NOTICE OF PUBLIC MEETING PLANNING COMMISSION

Planning Commission
October 26, 2023 @ 5:30 PM

Staff Report

Request: Pioneer Pointe Subdivision, Preliminary Plat

**PRELIMINARY PLAT
PIONEER POINTE**

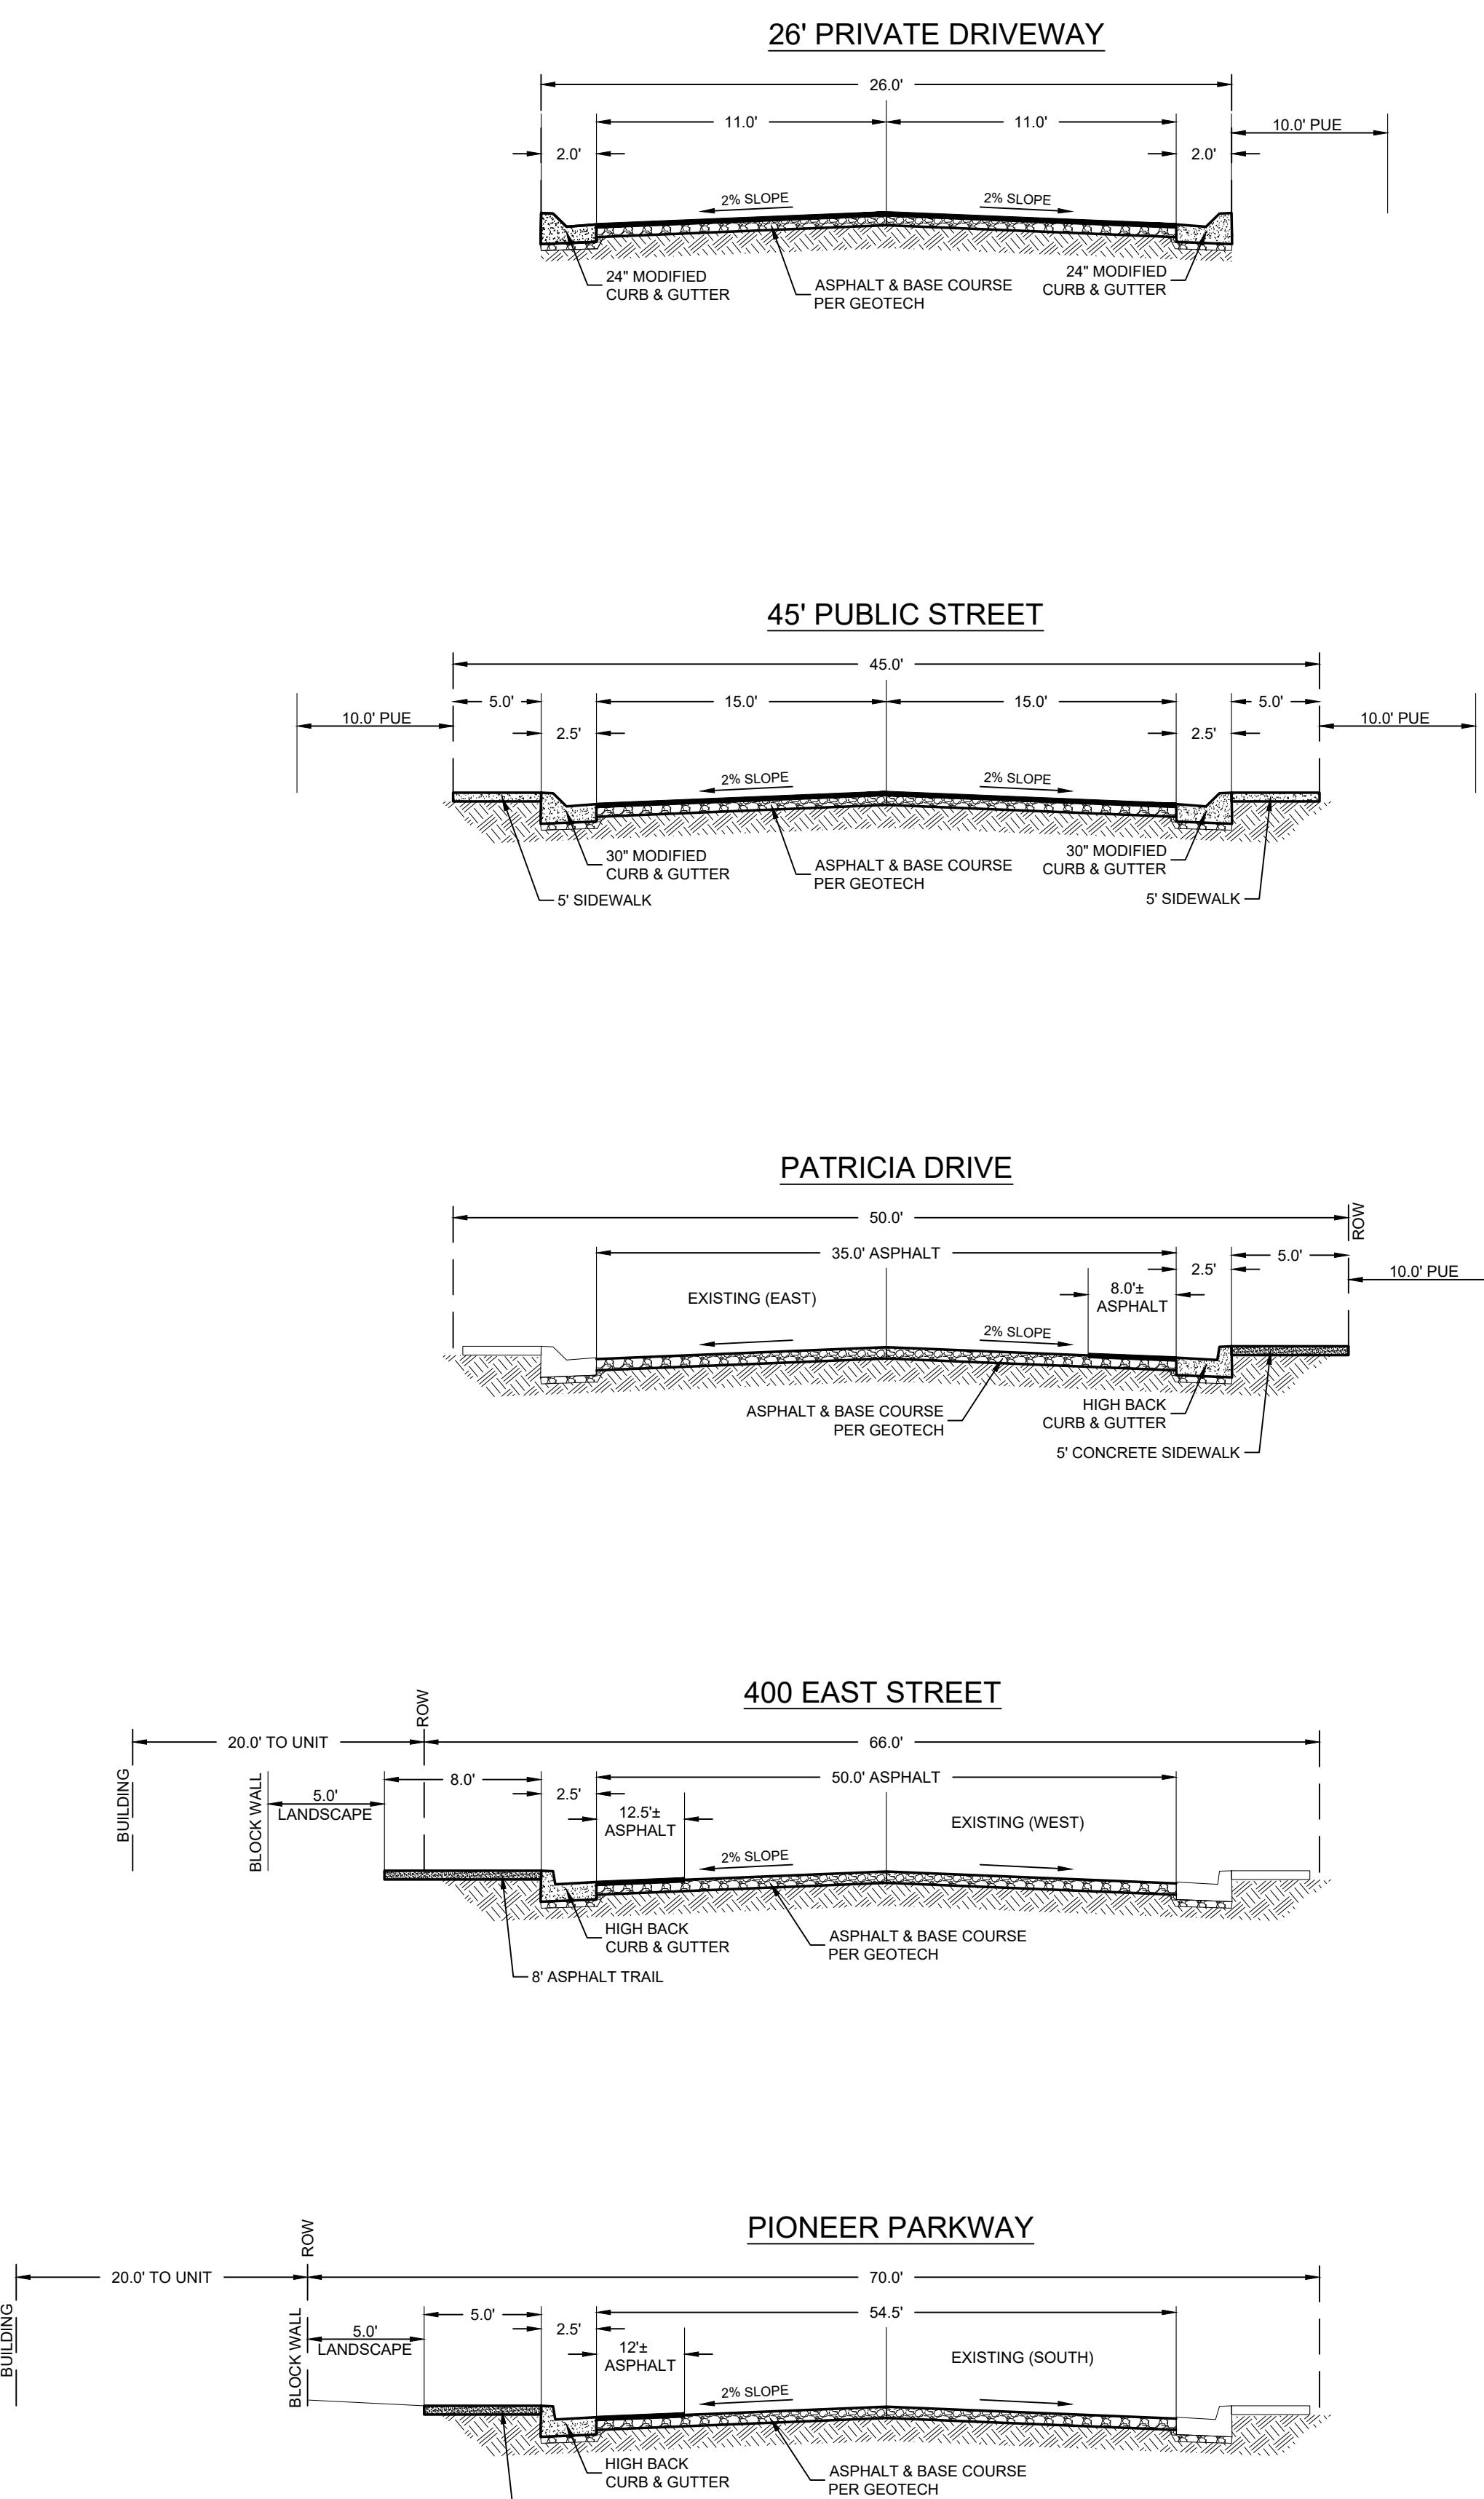
1. **Residential Unit Count:** The Preliminary Plat Plan includes a **total of one hundred thirty-three (133) units** on 18.09 acres of property. This equates to a **density of 7.35 units/acre**. A total of 82 single-family lots/pad lots are proposed along with 51 multi-family townhome units.

2. **Project Phasing Plan:** A Phasing Plan has been included for the overall project. **A total of seven (7) phases are proposed** by the developer. Each phase will include the following:

4. **Open Space:** Chapter 17.68 requires at least 30% of a project area to be in common open space. The Preliminary Plat includes approximately **34.83% (6.30 acres)** of open space being proposed for the overall project. The applicant is required to work with city staff during both the Preliminary and Final Subdivision Plat review to verify these calculations.

5. **Public Trail Access:** An 8' asphalt public trail along 400 East has been shown on the Preliminary Subdivision Plat. This trail is required as per the **2018 Trails Master Plan.** This required trail will tie in with the existing section of trail along the 400 East frontage of the Tuscany project, which provides a connection to other trails in the area. The applicant is required to work with city staff during both the Preliminary and Final Subdivision Plat review process.

7. **Public Road Cross-Section:** The Preliminary Plat includes a required 45' public road cross-section within the interior of the project. **This includes 30' of asphalt, 2.5' of curb and gutter on either side, with a 5' sidewalk on each side of the road allowing for good pedestrian access and movement.** Additionally, improvements such as but not limited to curb & gutter, park strip, sidewalk, and trails will be required along Patricia Drive (50' public street), Pioneer Parkway (70' public street), and 400 East (66' public street). The applicant is required to work with city staff and comply with all department recommendations during both the Preliminary and Final Subdivision Plat review process.

8. **Private Driveway Cross-Sections:** The Preliminary Plat includes **two (2) private driveways at 26'.** Each private driveway would provide access to two (2) single-family pad lots (**Lots 38-39, and 59-60**). The applicant is required to work with city staff and comply with all department recommendations during both the Preliminary and Final Subdivision Plat review process.

9. **Parking:** The Preliminary Plat includes **203 parking spaces for the 51 multi-family townhome units**. This equates to 4.0 parking spaces per unit. An additional 20 surface parking spaces have been provided adjacent to the project amenities in Phase 1B, and within Phase 5. **Chapter 17.32 requires two (2) parking spaces per unit, one covered and one uncovered. Each of the single-family lots/pad lots have been designed to include a two-car garage with a two-car driveway.** The project parking will be reviewed during both the Preliminary and Final Subdivision Plat review process.

6. That the project amenities be provided and put in place as per the approved Phasing Plan.
7. That the required public multi-purpose trail along 400 East (2018 Trails Master Plan) be put in place as per the Preliminary Subdivision Plat.

9. That a 45' public road cross-section per the Preliminary Subdivision Plat be required for the interior streets within the project. That a 26' private driveway be allowed to access Lots 38 – 39, and 59 – 60 only. That future improvements to Patricia Drive, Pioneer Parkway, and 400 East meet city requirements and be improved as indicated in the staff report.

10. That 203 parking spaces for the 51 multi-family units be provided along with 20 surface parking spaces adjacent to the amenity area in Phase 1B, and within Phase 5 as per the Preliminary Subdivision Plat and Phasing Plan.

WALL DETAIL

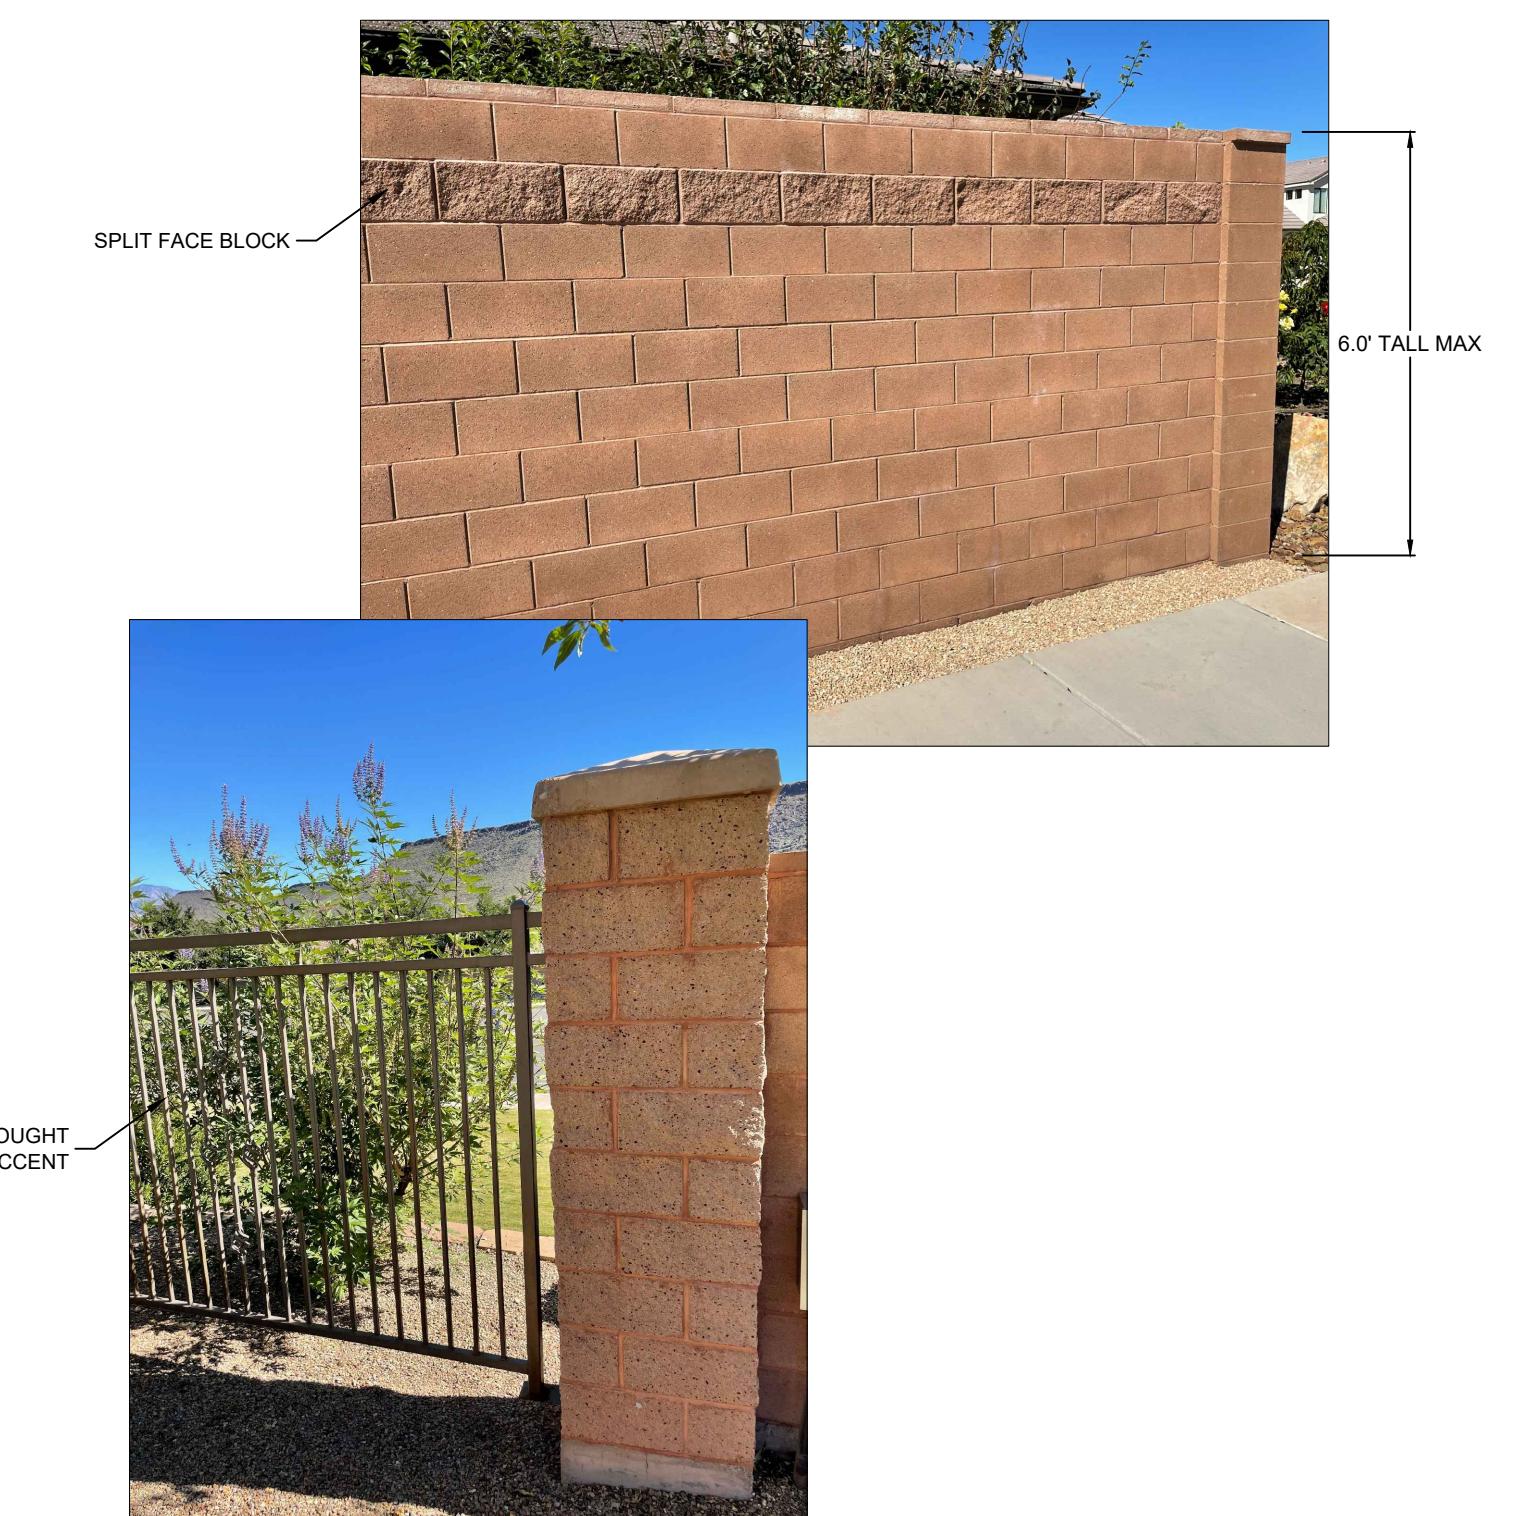
13. **Block Privacy Wall:** **A 6' solid block privacy wall will be required along Pioneer Parkway and 400 East.** A block wall detail and color sample has been included with the Preliminary Plat. City staff would recommend that **more specific details be required at Final Plat submittal.**

13. That a 6' solid block privacy wall be required along Pioneer Parkway and 400 East. That more specific detail be provided at Final Plat submittal.
14. That 50% of all units in the project be owner-occupied. That this requirement be included in the CC&Rs and enforced by the HOA.

PHASING

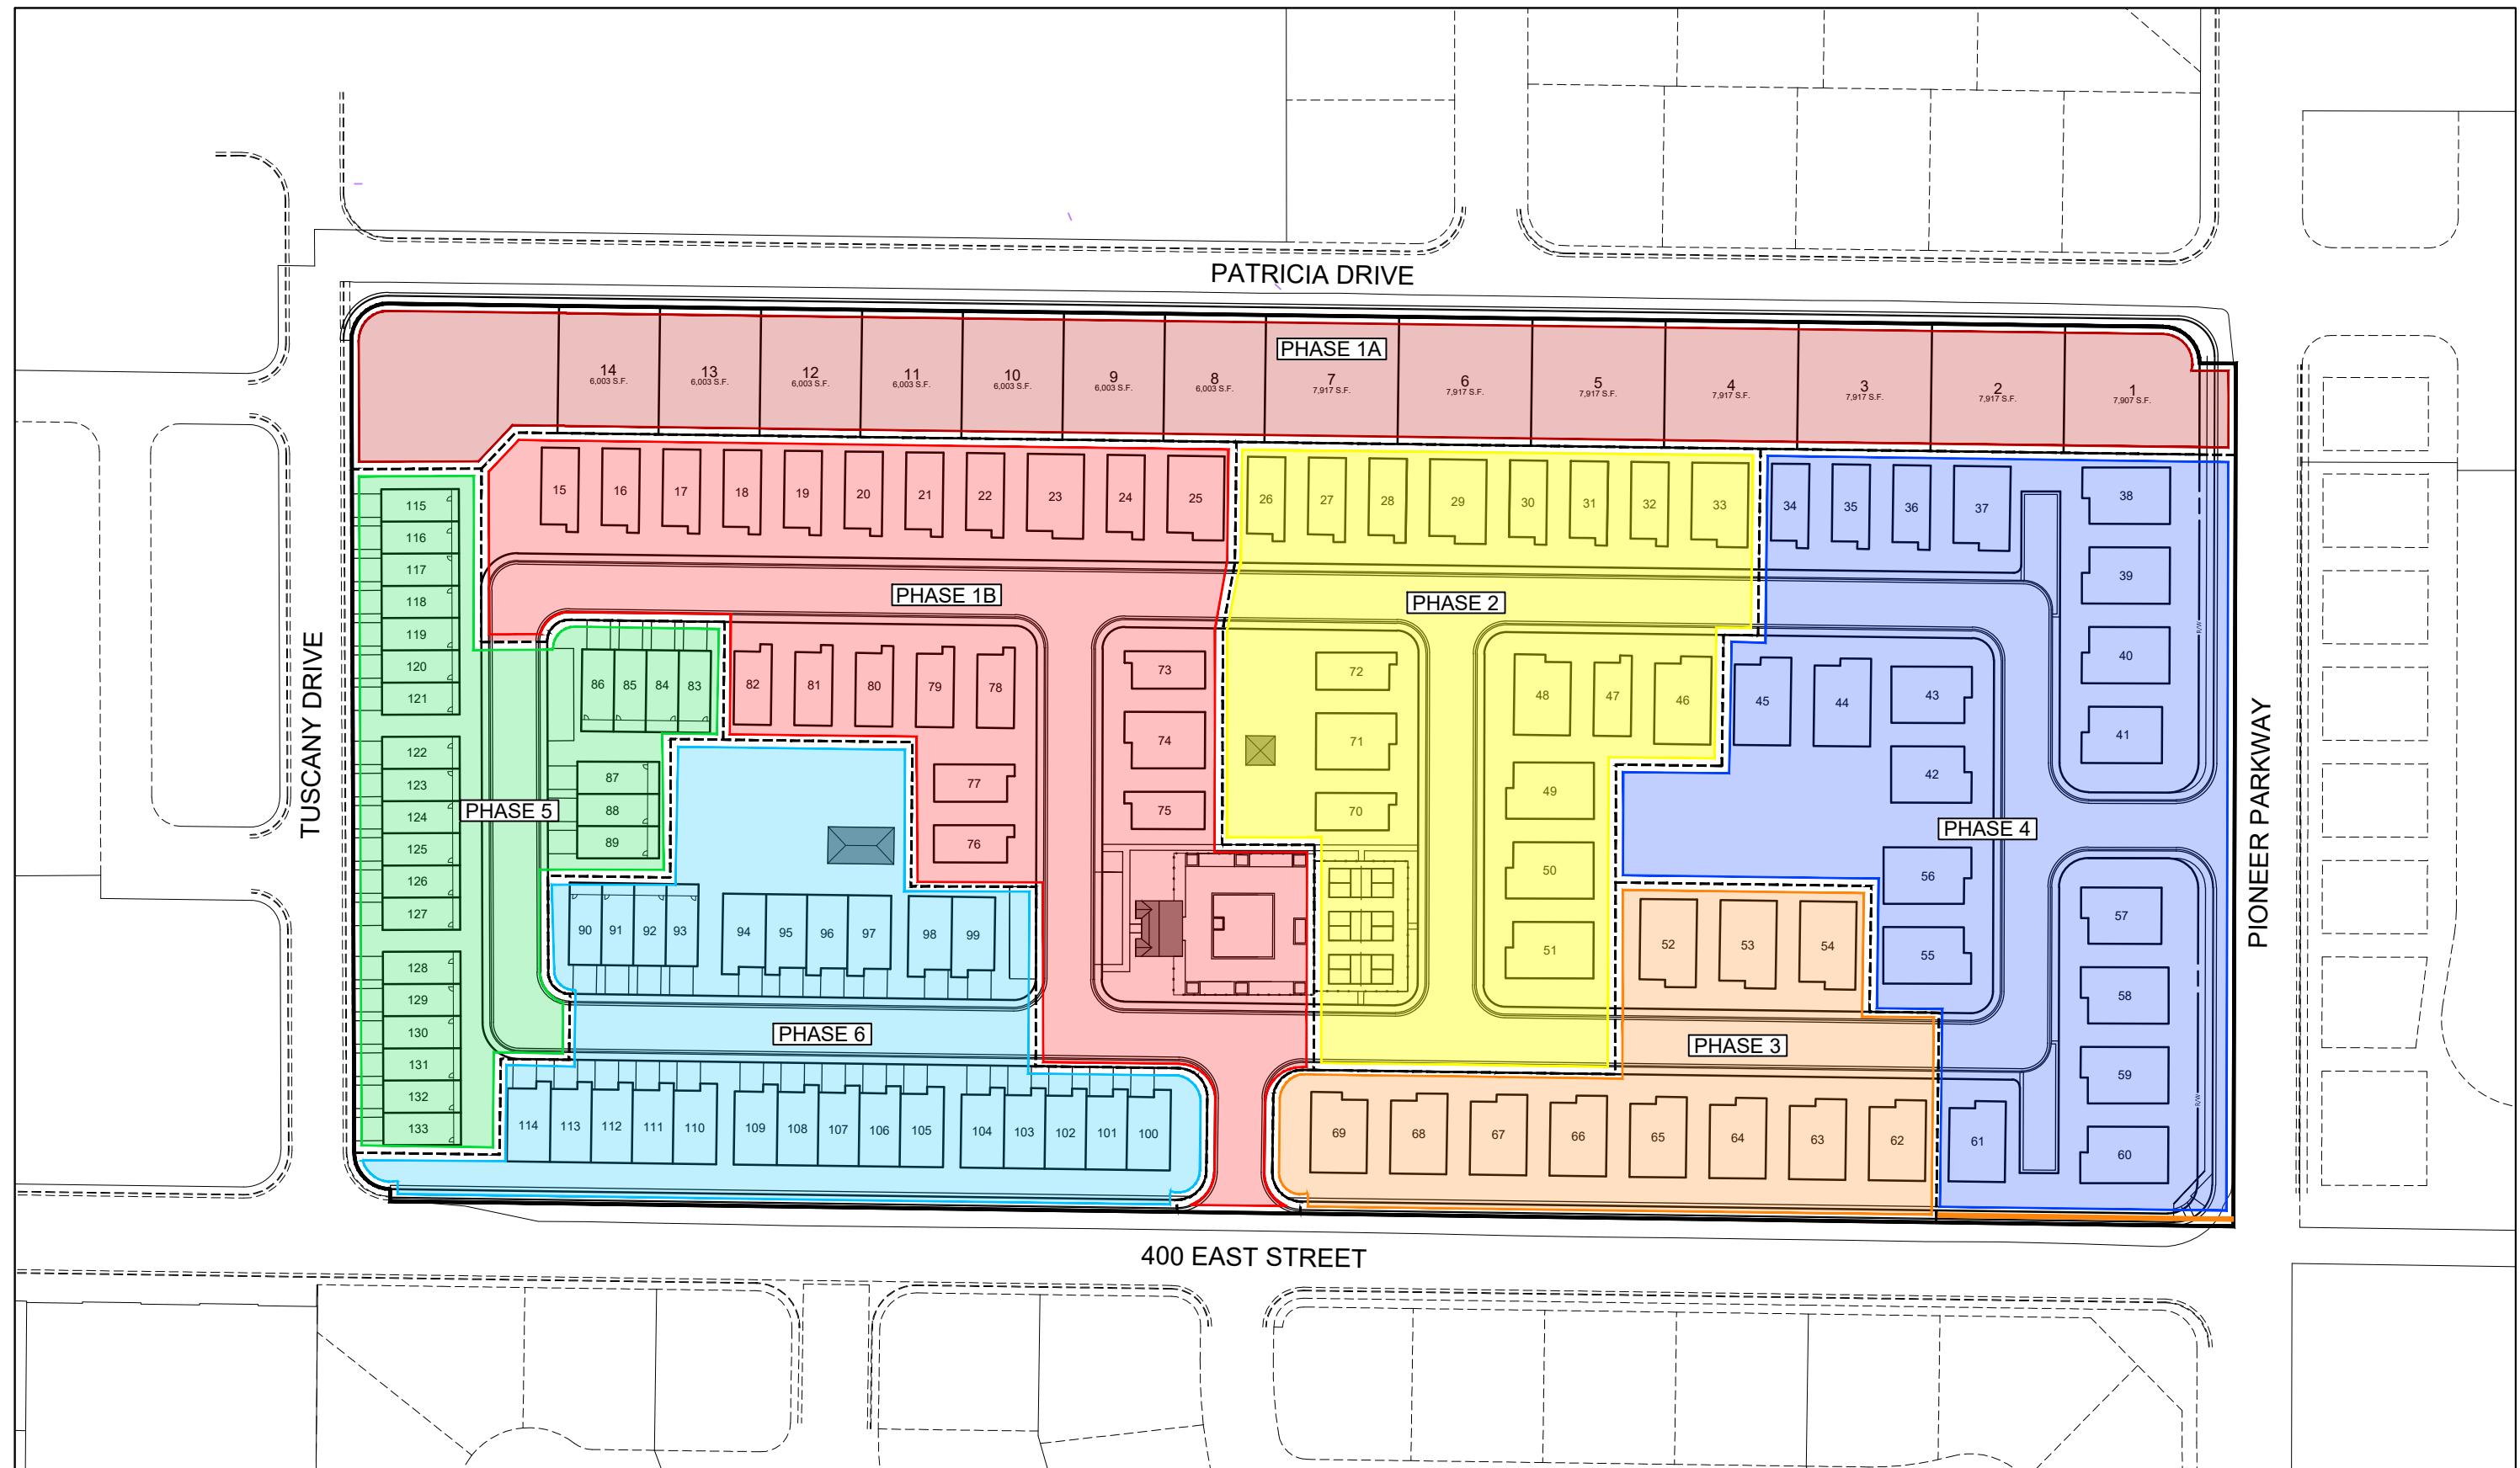
- **Phase 1A** includes 14 single-family lots with a detention basin area.
 - **Phase 1B** includes 21 single-family pad lots, amenity area parking, and project amenities. These amenities include restrooms with changing areas, a large pool, hot tub, and an outdoor seating (covered and uncovered) area for the community.

- **Phase 2** includes 11 single-family pad lots with project amenities. These amenities include three (3) pickleball courts, a green court/open space area with walking paths, and a pavilion.

- **Phase 3** includes 11 single-family pad lots.
 - **Phase 4** includes 19 single-family pad lots with project amenities. This amenity area includes a large green court/open space area with walking paths.

- **Phase 5** includes 26 multi-family townhomes units in five (5) buildings, and visitor parking.
 - **Phase 6** includes 25 multi-family townhome units in six (6) buildings with project amenities. This amenity area includes a large green court/open space area with walking paths and a large pavilion.
